UNITED STATES
DEPARTMENT OF THE INTERIOR
BUREAU OF LAND MANAGEMENT

FORM APPROVED
OMB NO. 1004-0137
Expires: January 31, 2018**SUNDRY NOTICES AND REPORTS ON WELLS**
*Do not use this form for proposals to drill or to re-enter an abandoned well. Use form 3160-3 (APD) for such proposals.*5. Lease Serial No.
NMNM108456

KIAWAH BFQ FEDERAL 1

EOG Y Resources, Inc. plans to plug and abandon this well as follows:

Before

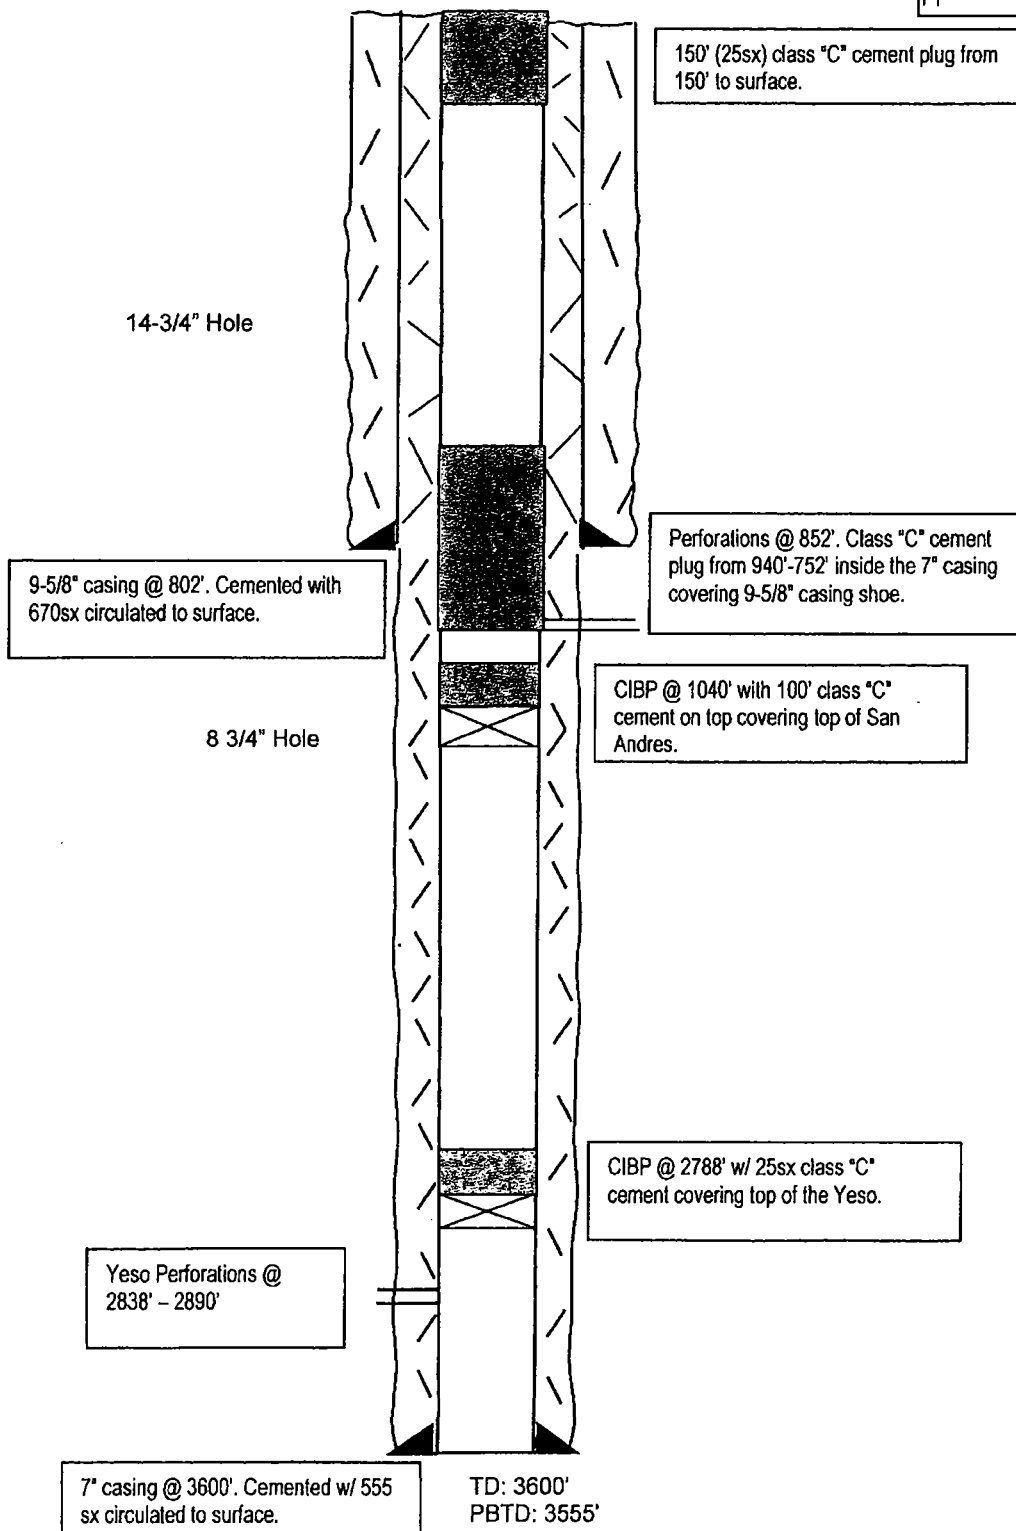
1. MIRU all safety equipment as needed. POOH with production equipment.
2. RIH with bit and scraper 2788 ft
3. Set a CIBP at 2788 ft with 25 sx of Class C cement on top. This will cover the top of Yeso. WOC. Tag TOC. *Tag 20 lower than 2608. Covers T/Yeso & T/Glorieta*
4. Set a CIBP at 1040 ft with 100 ft Class C cement on top. This will cover the top of San Andres. WOC. Tag TOC. *or spot 25 sx plug from 1040-940*
5. Perforate at 852 ft. Attempt to establish circulation between 9-5/8 inch and 7 inch casing.
6. If no circulation see step 7. If able to circulate see step 8.
7. Spot a 35 sx (188 ft) Class C cement plug from 940 ft ? 752 ft. This will cover the 9-5/8 inch casing shoe. *WOC Tag*

*Records indicate Both 9 5/8" & 7" Circ. to Surf. Perf/sec NO Required.***SEE ATTACHED FOR
CONDITIONS OF APPROVAL****NM OIL CONSERVATION**
